Product Change Notification Letter

Title: Packing Method Improvement for Die Sale
Products Packed by 3'' Trays

PCN #: 08-08

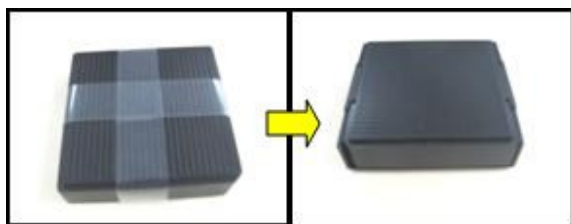
PTI would like to announce that the packing method for die sale products packed by 3'' trays would be changed for improvement. The detailed description of change is shown as below:

Item	Before change	After change
Material:	Tape	Clamp
Surface resistance:	$>10^{11}$	10^5 to 10^{11}
ESD Sensitive:	Insulative	Dissipative
